Date July 15, 2020  
To Town of Cumberland Planning Board  
From Carla Nixon, Town Planner  
Subject **Major (Preliminary) Subdivision and Site Plan Review: Cumberland Crossing, Phase 2 - Tuttle and Greely Roads.**

The Applicant is Oceanview at Cumberland, LLC. The Applicant is requesting Preliminary Major Subdivision and Site Plan Review for an additional 52 lots and a community center on a 59.59 acre parcel that is connected to Phase 1 by a triangular piece of land in the southwest corner of Phase 1 into Phase 2.

| FIELD WK:       | SCALE: 1"=40' | SHEET:<br><br><b>C3B</b> |

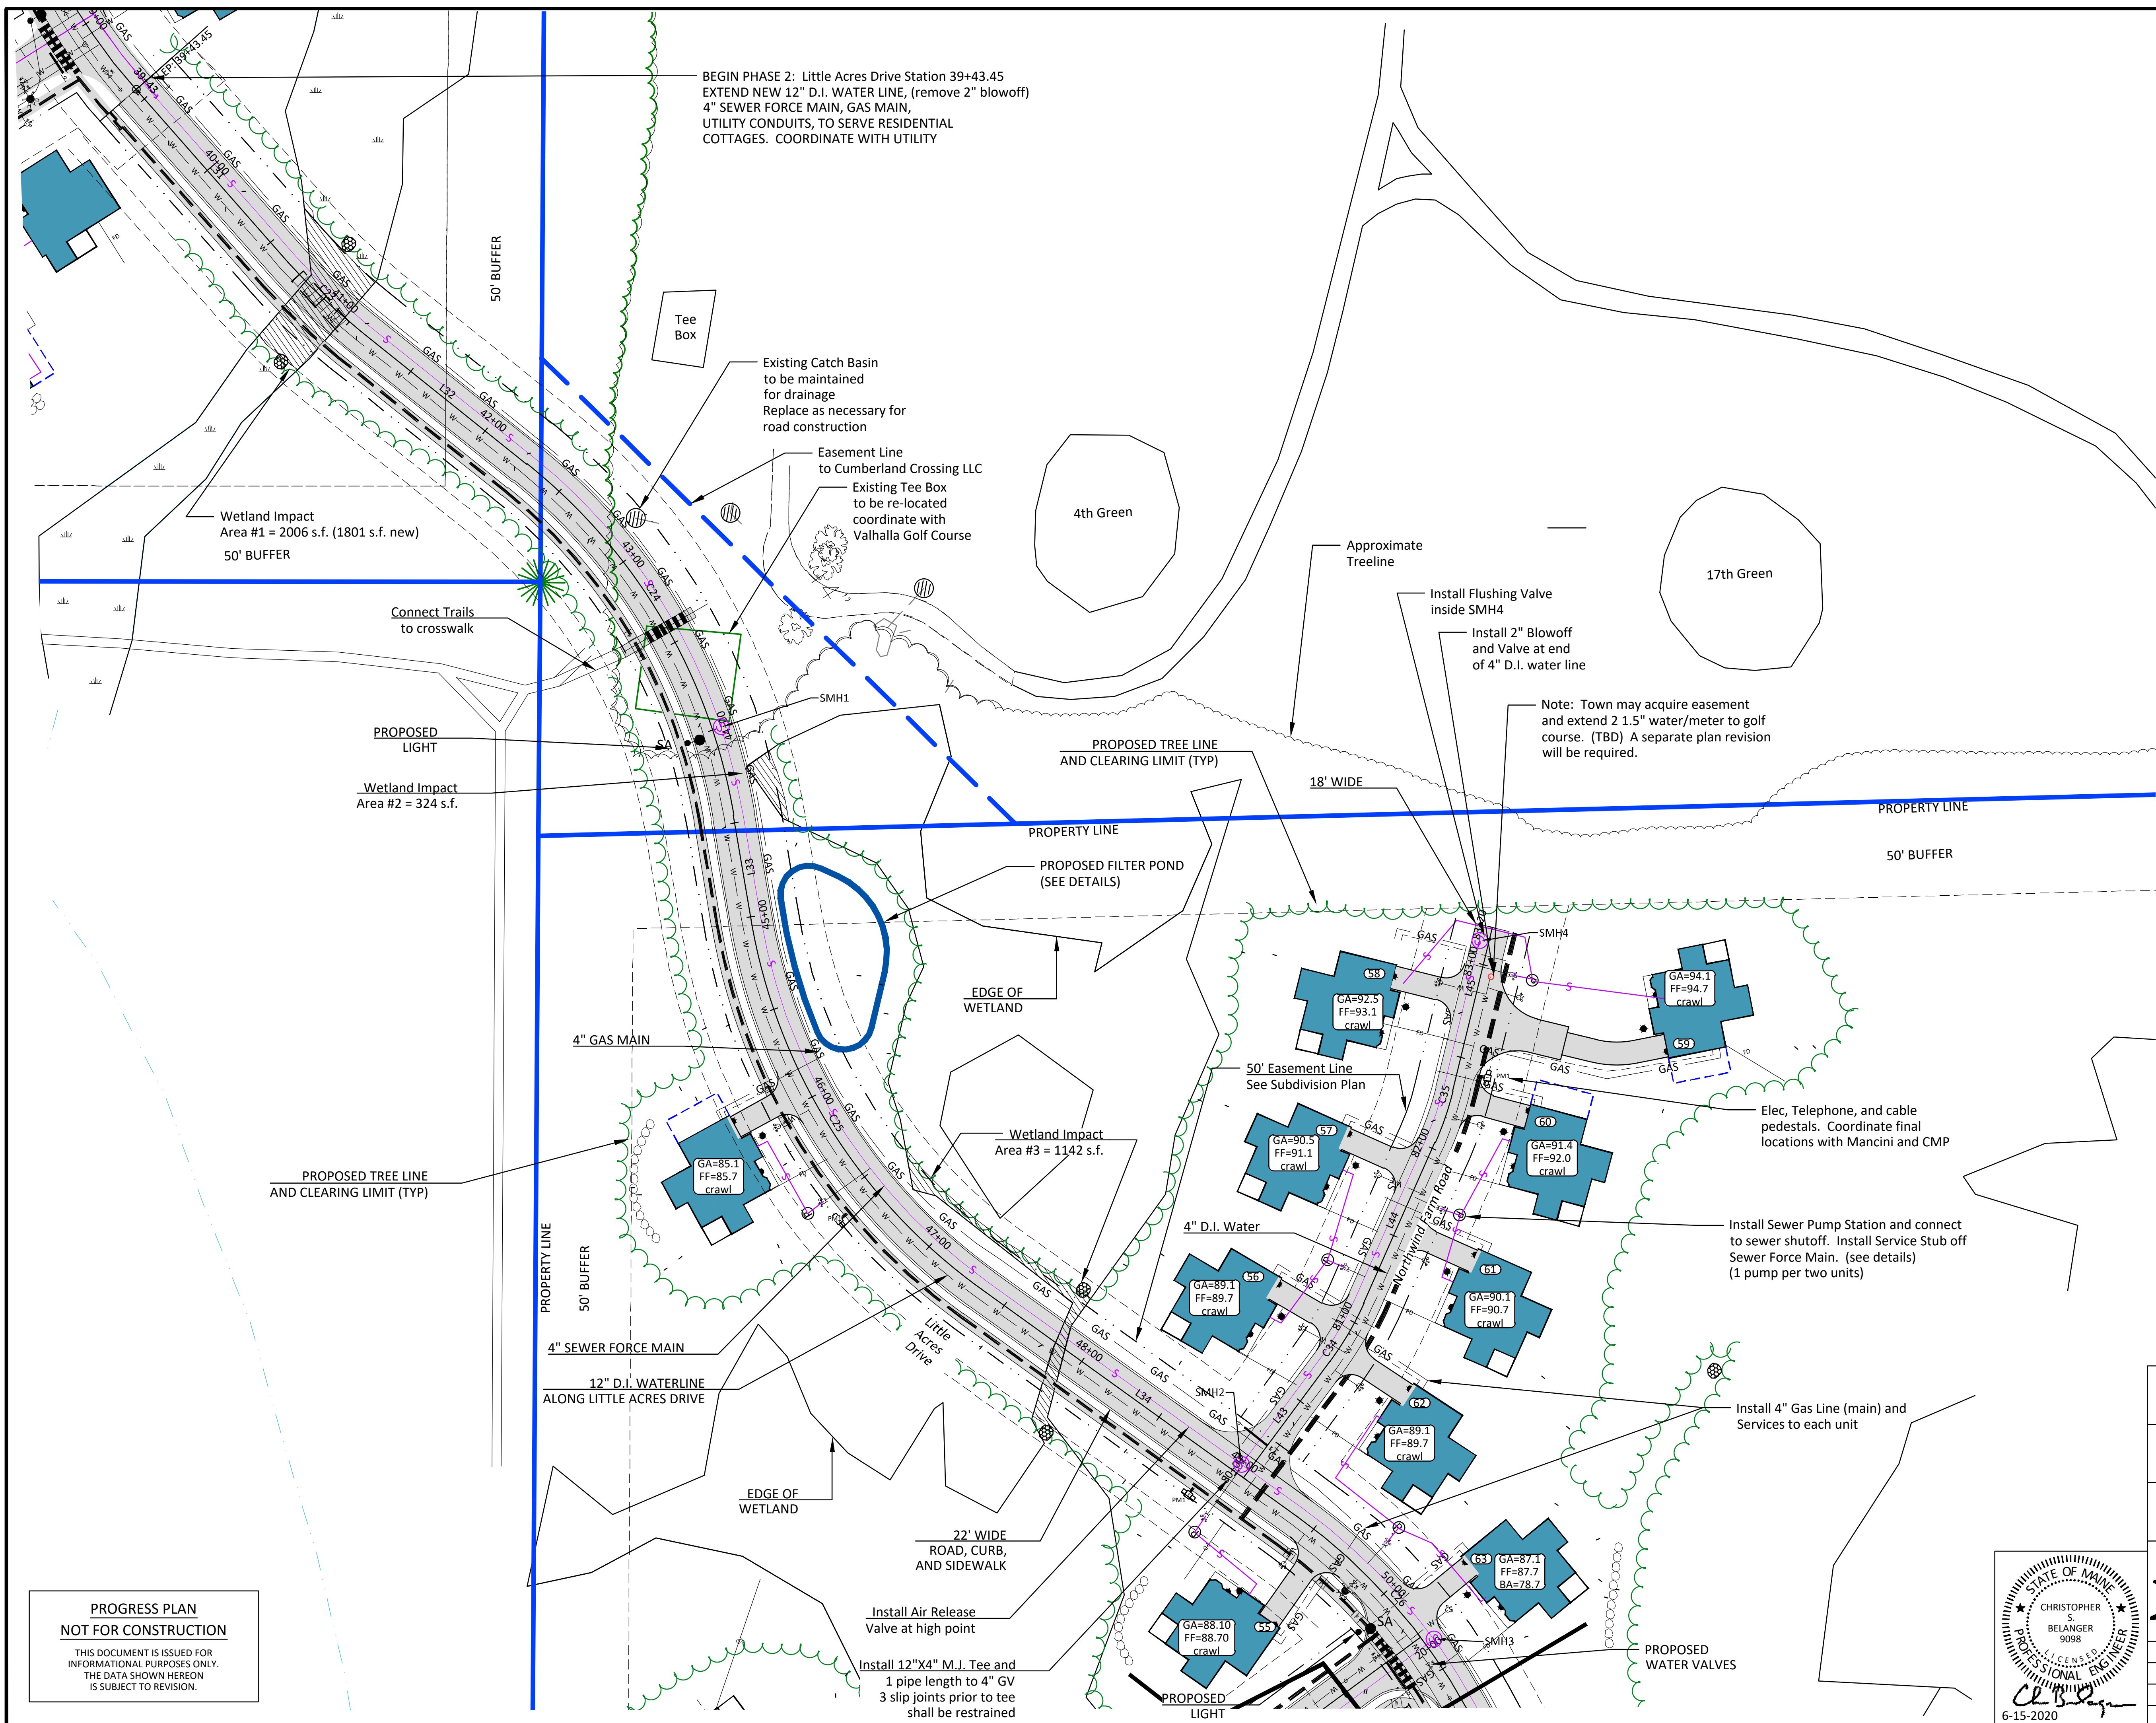
12. Plan Sheet 3B/4B/5B/6B – The sewer line does not appear to be on in the plan drawing.

| SCALE: 1"=40' H, 4' V<br>JOB #: 134<br>DATE: 6-15-2020   | SHEET:<br><b>C8</b> |

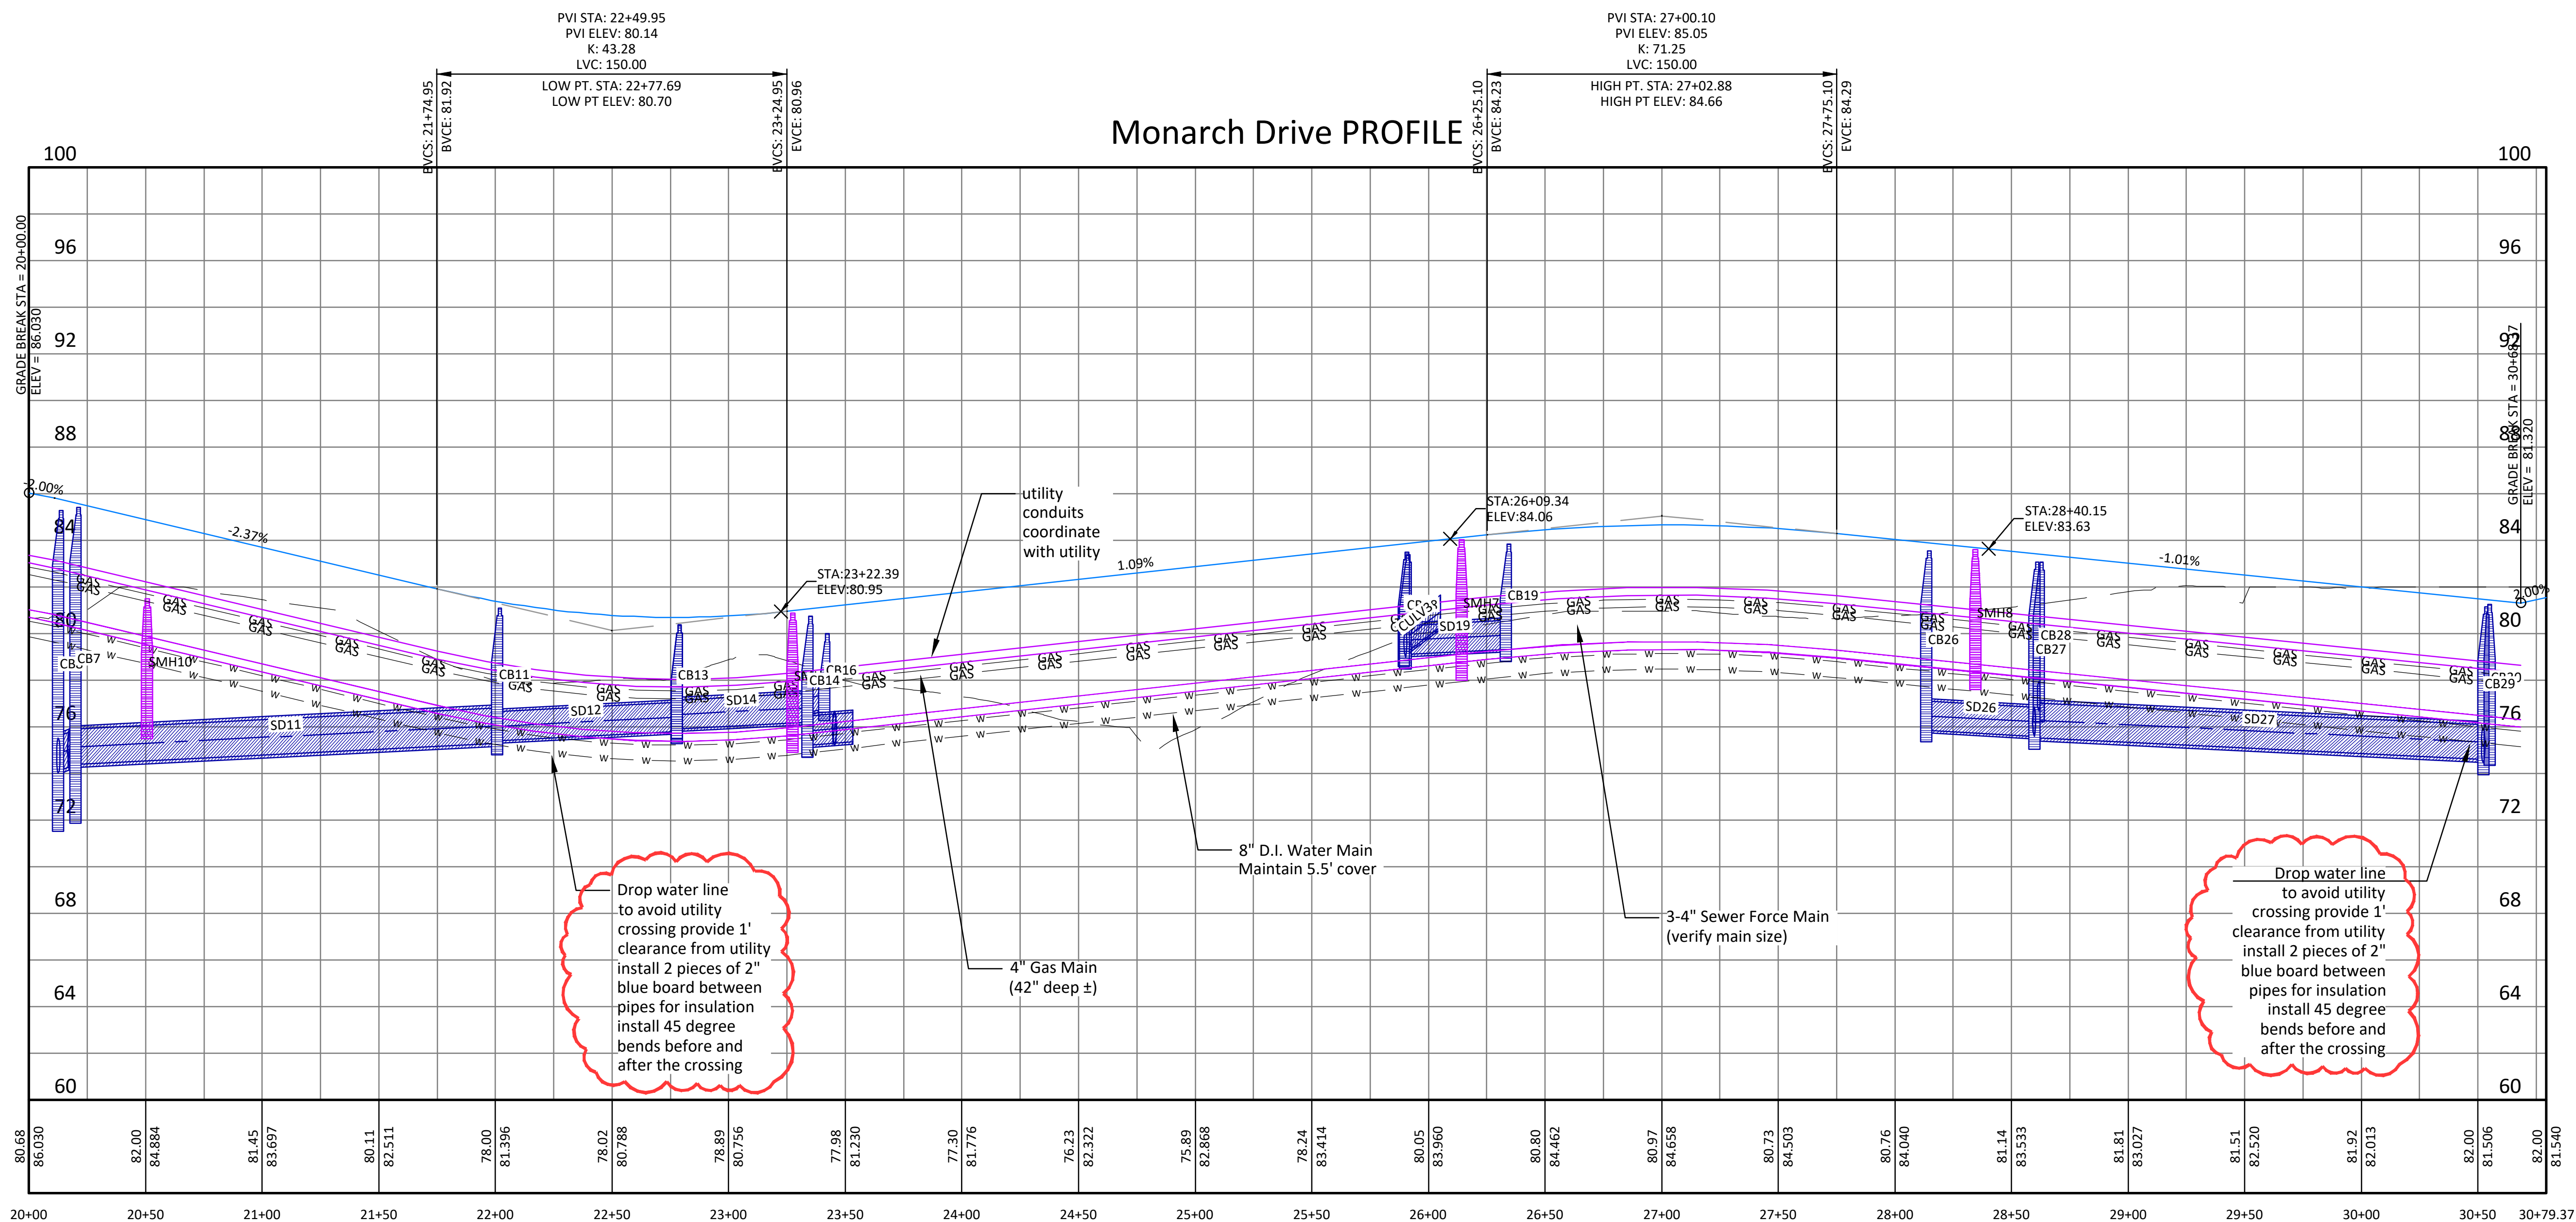
29. Plan Sheet C7 – Please add sewer manholes to profile sheet. **Plan has been updated.**
30. Plan Sheet C8 – Please add vertical grid labels for review of project specifics. **Plans have been updated.**
